Docket Nos. 50-280 ✓
and 50-281

License Nos. DPR-32
and DPR-37

Change No. 8

Your letter dated July 5, 1973 enclosed proposed Technical Specification Change No. 8, which supersedes your proposed Technical Specification Change No. 8 requested in your letter of June 4, 1973. The proposed changes are required in order to implement a reduced primary system pressure program to preclude fuel collapse during the first fuel cycle.

Figure 2.1-2. Reactor Core Thermal and Hydraulic Safety Limits, Two Loop Operation, Loop Stop Valves Open

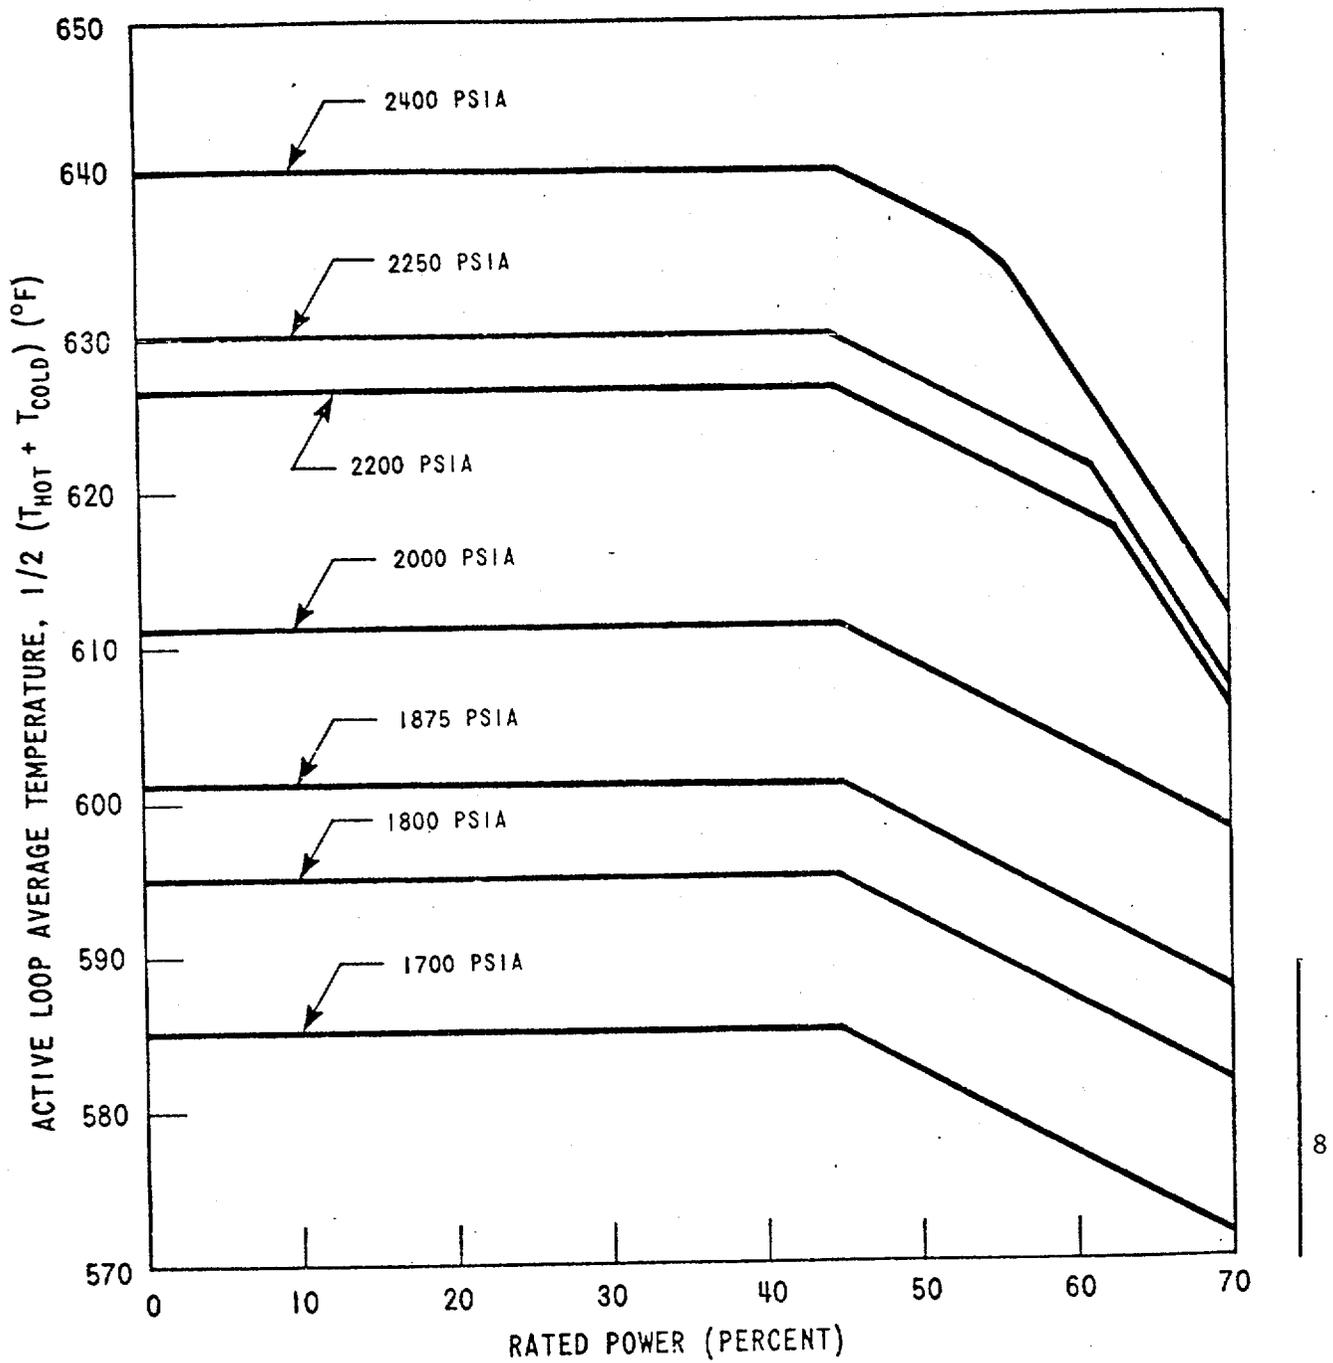
The overpower and overtemperature protection system setpoints have been revised to include effects of fuel densification and reduced pressure operation on core safety limits. The revised setpoints in the Technical Specifications will ensure that the combination of power, temperature, and pressure will not exceed

the revised core safety limits as shown in Figures 2.1-1, 2, and 3.

Figure 3.12-1 Control Bank Insertion Limits for Normal 3 Loop Operation

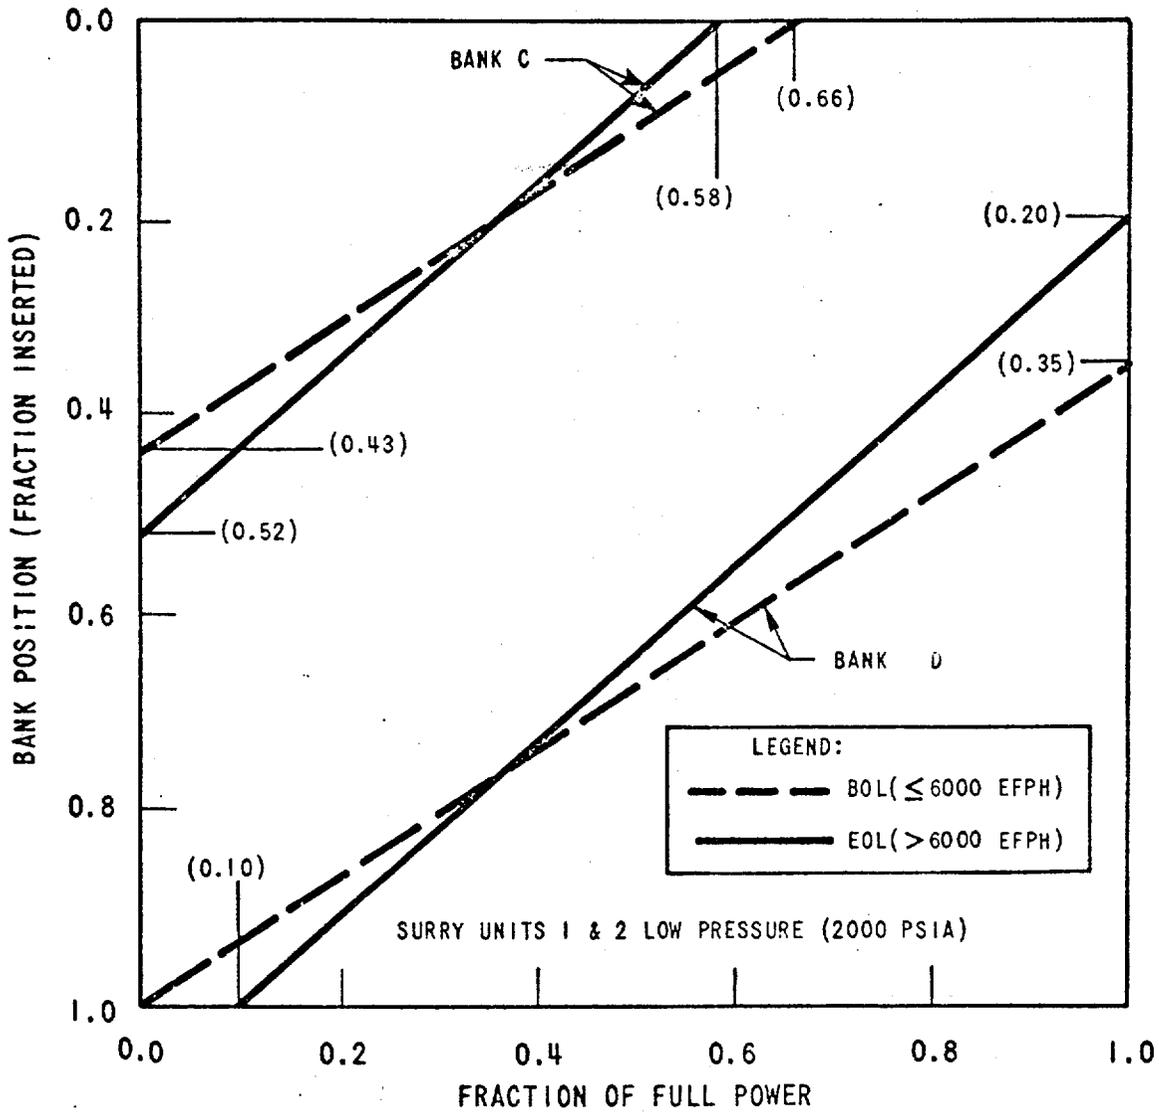
Accordingly, pursuant to Section 50.59 of 10 CFR Part 50, the Technical Specifications of Facility Operating License Nos. DPR-32 and DPR-37 are hereby changed as follows: replace pages TS Figure 2.1.1, TS Figure 2.1.2, TS Figure 2.1-3, TS 2.3-1, TS 2.3-2, TS 2.3-5, TS 2.3-6, TS Figure 3.12-1, and TS Figure 3.12-2 with the revised pages (designated as Change No. 8 on the bottom of the page) TS Figure 2.1-1, TS Figure 2.1-2, TS Figure 2.1-3, TS 2.3-1, TS 2.3-2, TS 2.3-5, TS 2.3-6, TS Figure 3.12-1, and TS Figure 3.12-2 enclosed.
